Re: Third Submission Review – The Aurora Highlands North – Area A - Site Plan
Application Number: **DA-2062-31**
Case Numbers: **2022-4027-00**

Third Submittal Review

TAH North – Area A

DEN Aviation Noise Analysis – TAH North – Area A

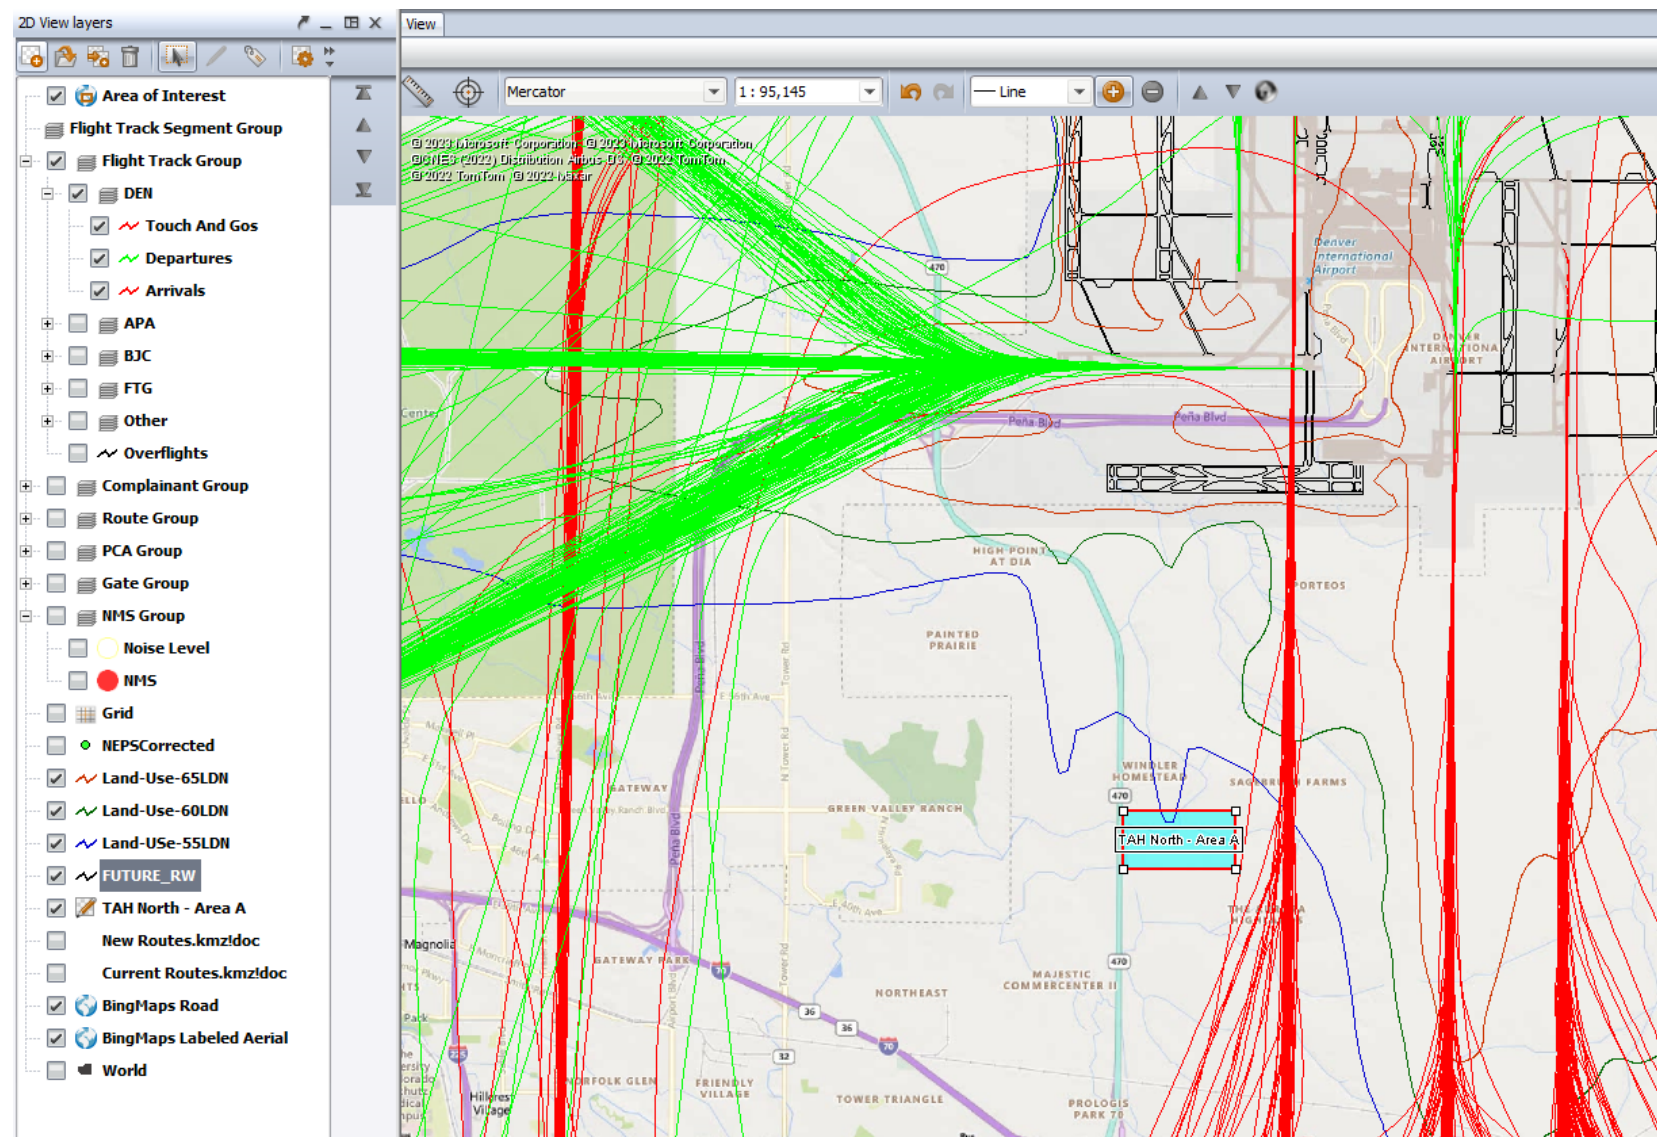
This property will be subject to overflights to and from Denver International Airport (DEN). Included are flight track maps showing the different flight track pattern scenarios and their altitudes related to the arrival and departure at DEN. All related aviation noise statements should be included in homeowner information, documentation and contracts.

Other areas in this development have been reviewed previously, and the noise analysis still holds true. This portion of the development will have arrival overflights from the south at altitudes of between 1,500 feet above ground level (AGL) and 4,100 feet AGL depending on the aircraft type and what arrival runway the Federal Aviation Administration (FAA) air traffic controllers have directed the aircraft to land on. If the winds are out of the north aircraft will land coming in from the south on final approach to DEN. Aircraft currently arrive to DEN on runways 34L and 34R and with the potential of 4 North/South runways on the West side of the airfield there could be even more daily arrival overflights of this development. The future runways are depicted in black on this map of flight data from 2/23/23. This days of flights depicts a typical flight pattern for a 24 period.

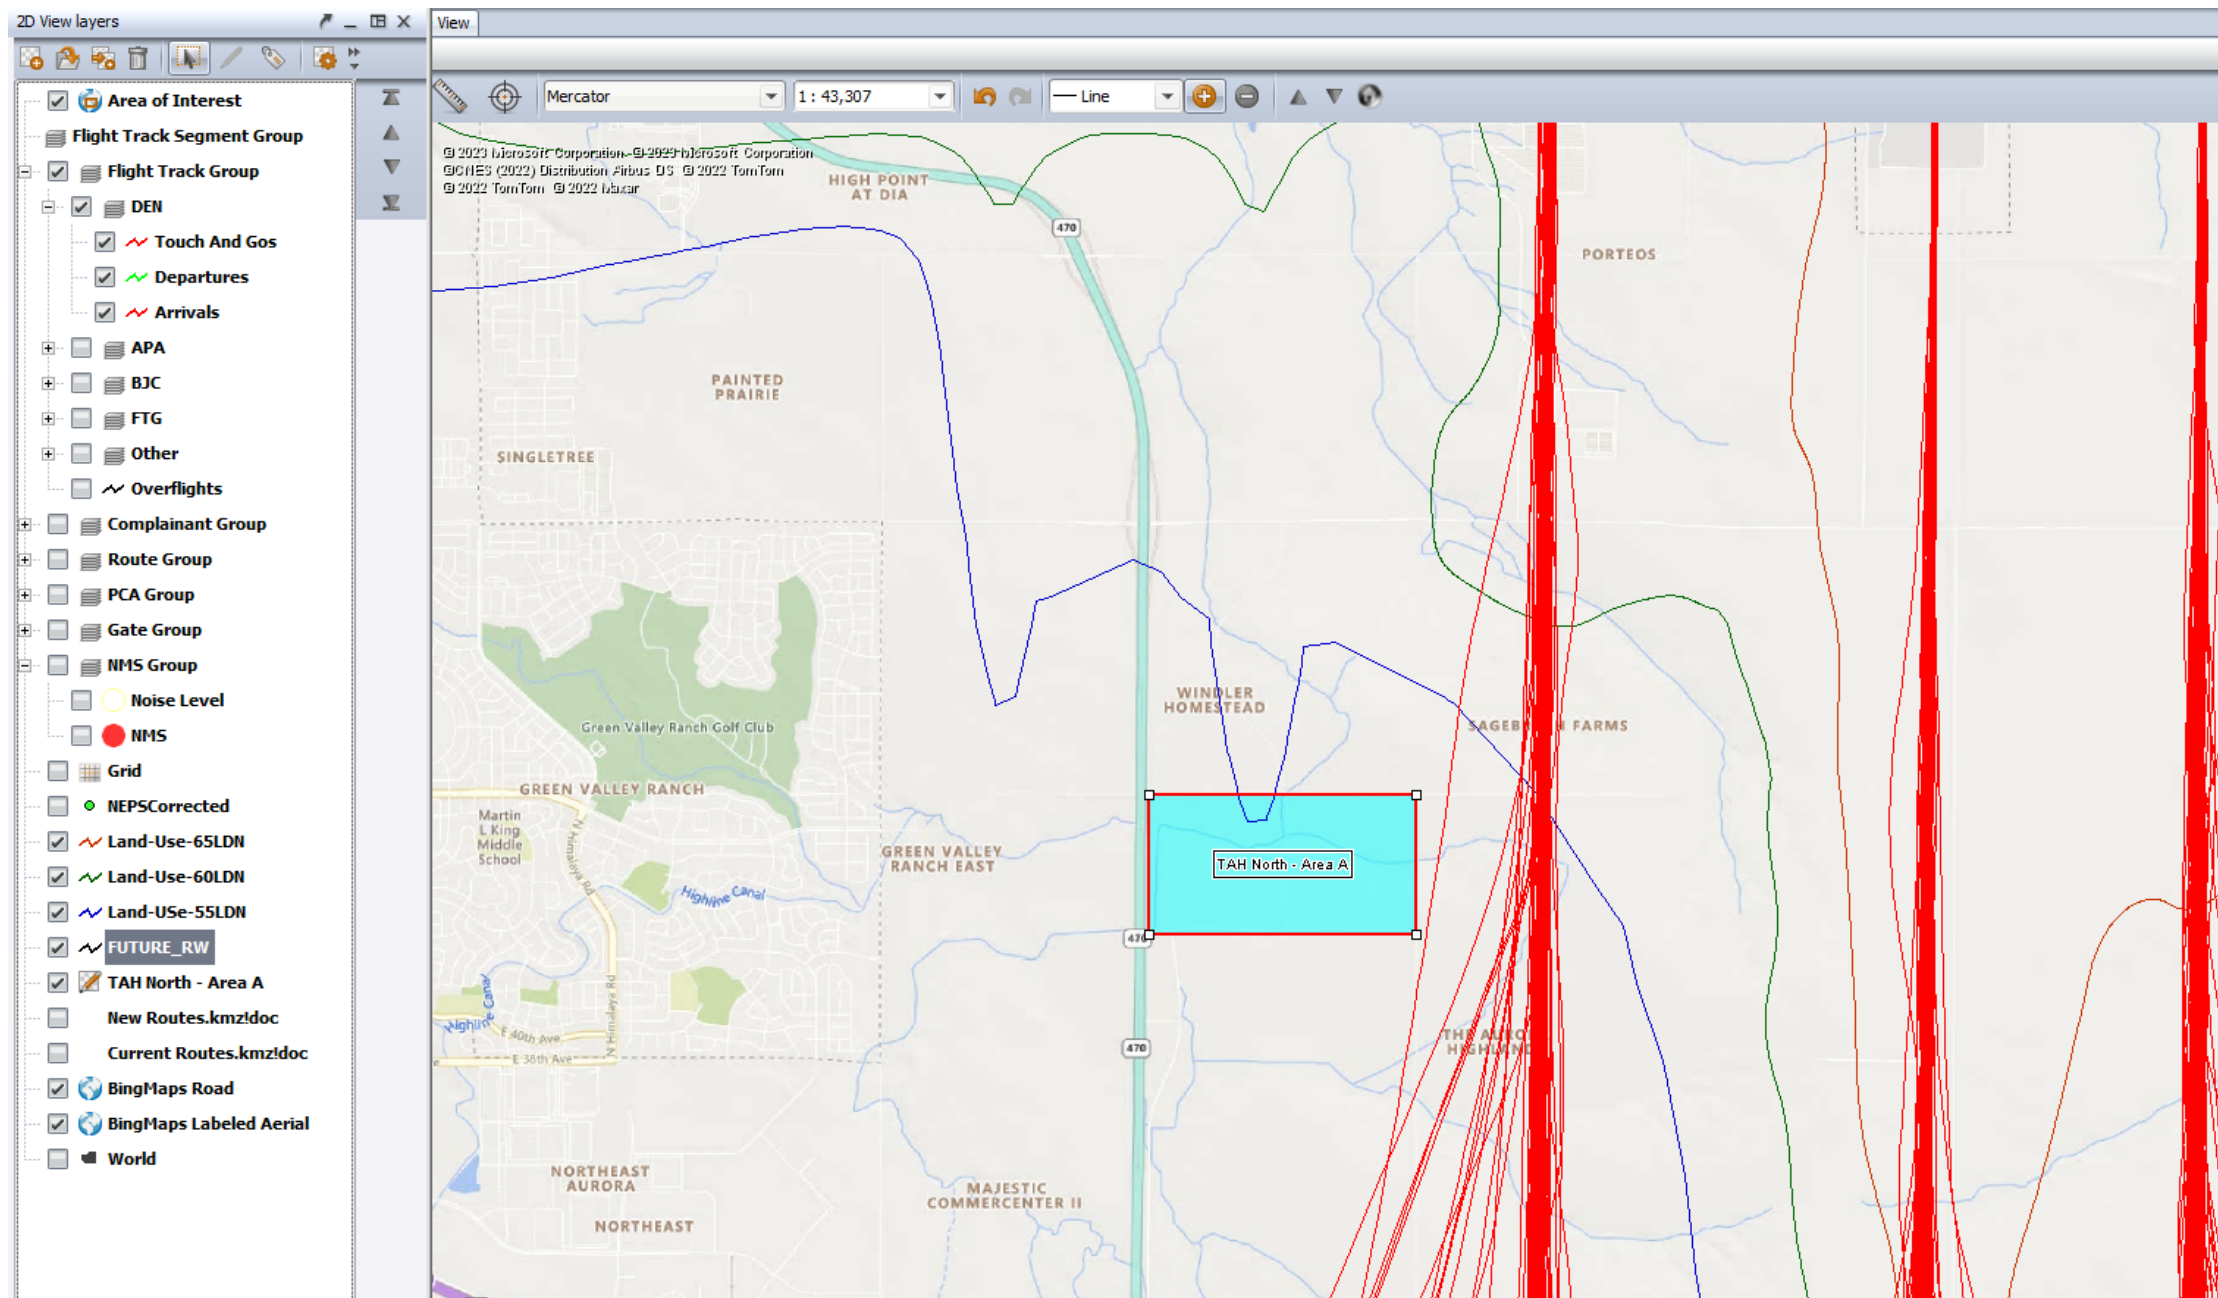
Same flight data from 2/23/23, zoomed in to see the 55, 60 and 65 DNL contour and the property area in light blue. The 55 DNL intersects the property on the north end. This portion of the 55 DNL pertains to the additional 2 potential north/south runways on the west side of the airfield. Once the runway straight north of this property is built, 16C/34C (might be the runway names) there will definitely be overflights at the beforementioned altitudes. There could be upwards of 200+ arrivals per day to that runway.

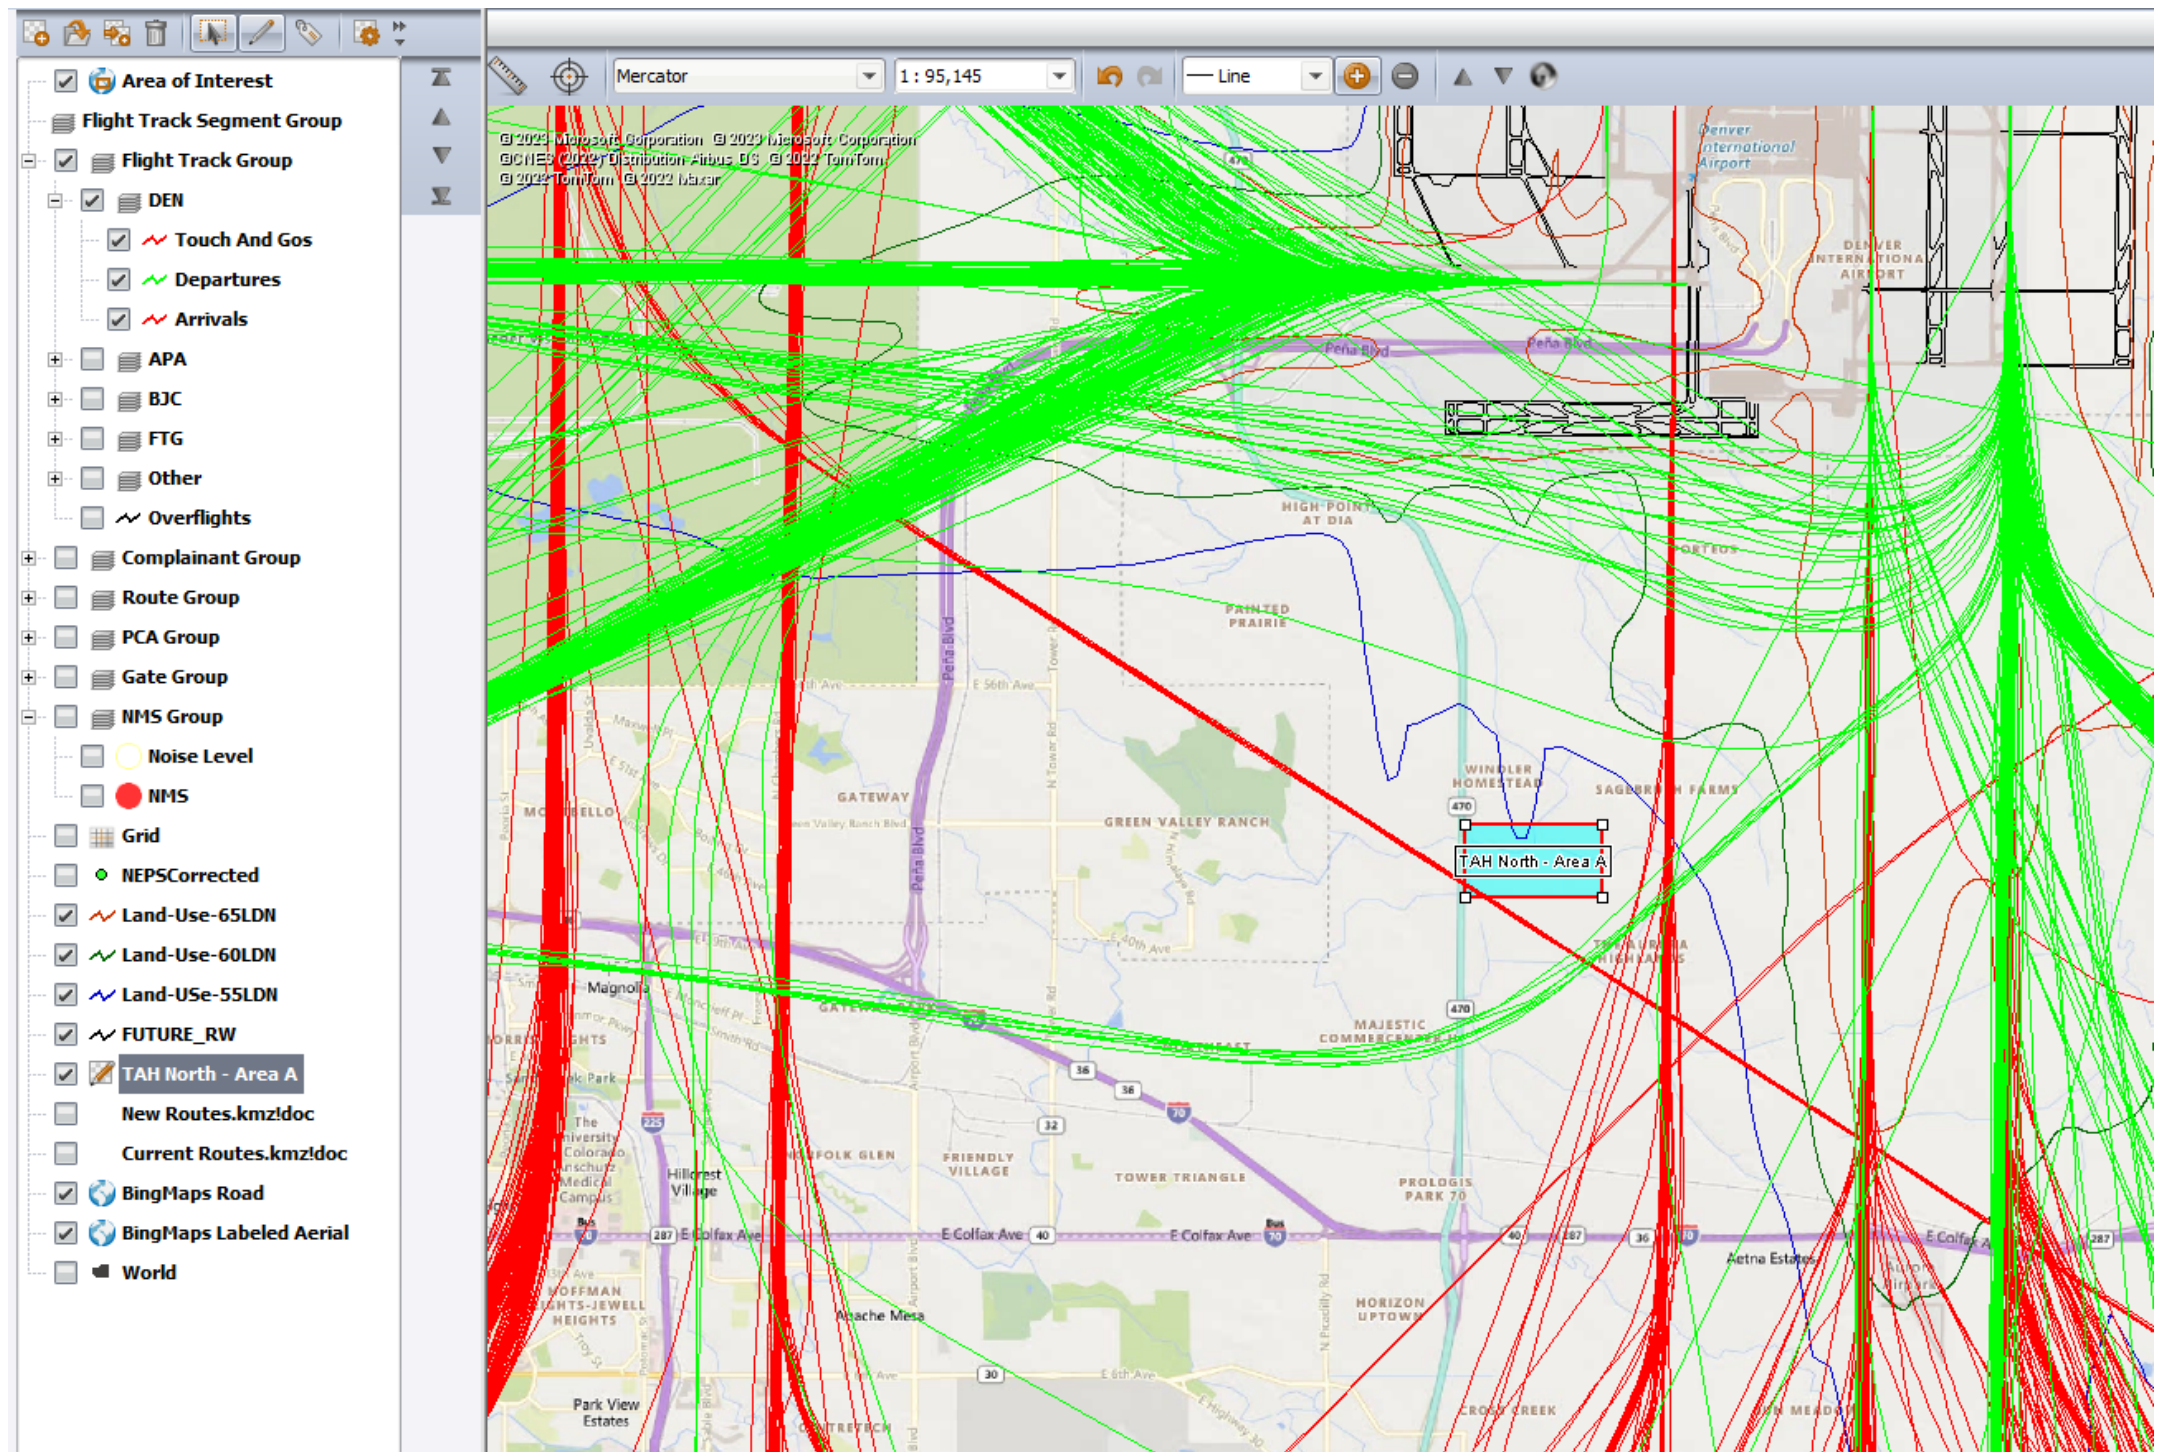
Flight data from 2/26/23. Few arrivals vectoring to get in line for final approach to 34L or 34R and there are also some departures that could fly near the subject property. On this day there were a few departures from runway 17L. They are approximately .30 - .45 miles to the southeast of that property. Their altitudes can vary based on aircraft type. On this day they were between 3,300 feet AGL and 4,100 feet AGL. These aircraft will be louder than arrivals as they are under full power departing DEN. During periods of high winds or inclement weather the FAA will depart aircraft to the south and then turn them west to get back onto the final pattern. This could happen from any one of the north south runways.
